# Few issues for New IP BPM system

John Adams Institute – University of Oxford

FONT group

## RF measurement data

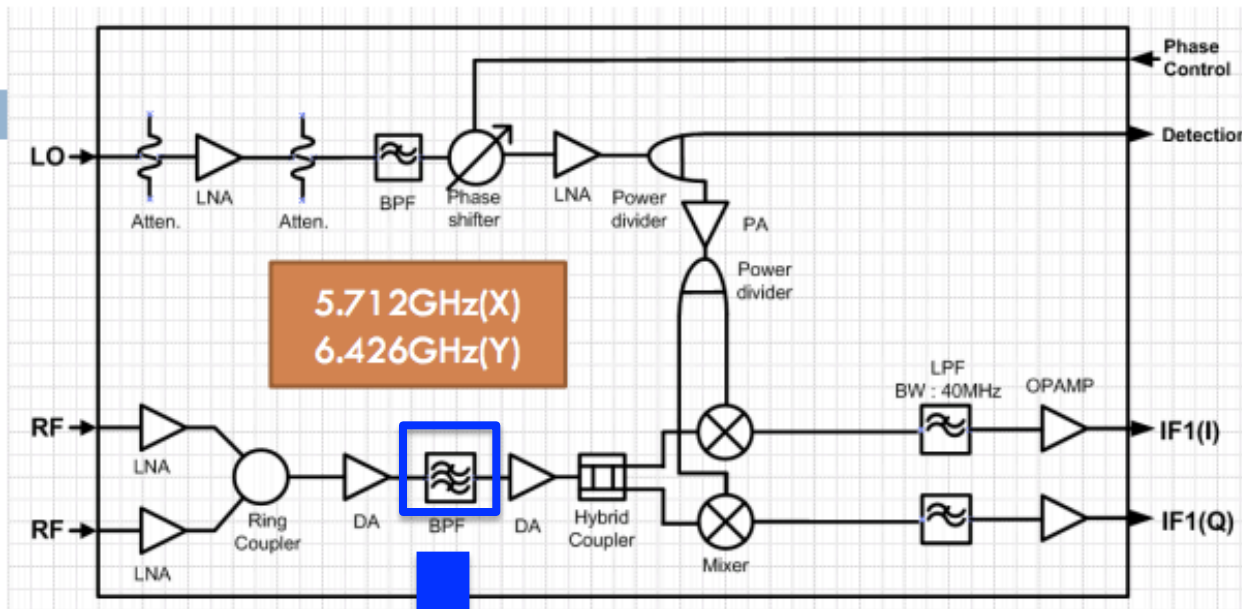
- Center frequency?
- Any plan to tune?
- Reference cavity frequencies?

Simplified schematic of the IP-BPM signal processing electronics.

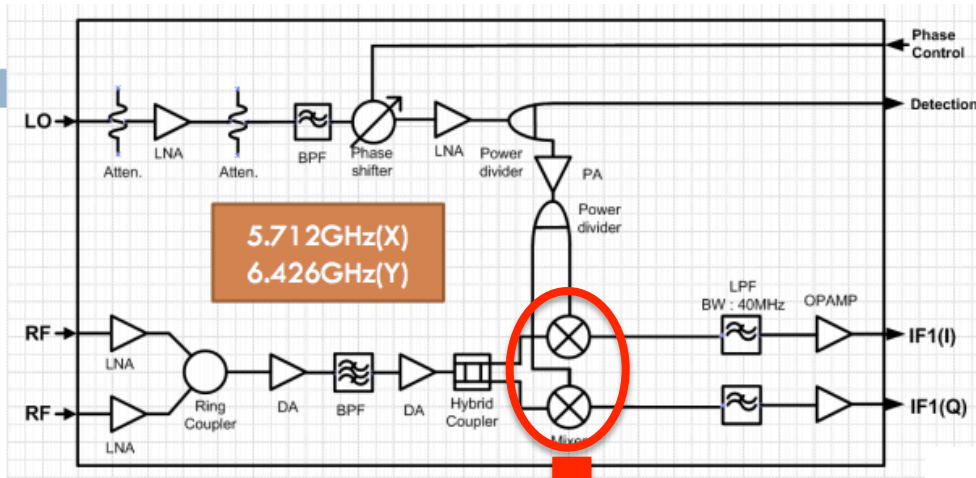
BPF center frequency? Bandwidth?
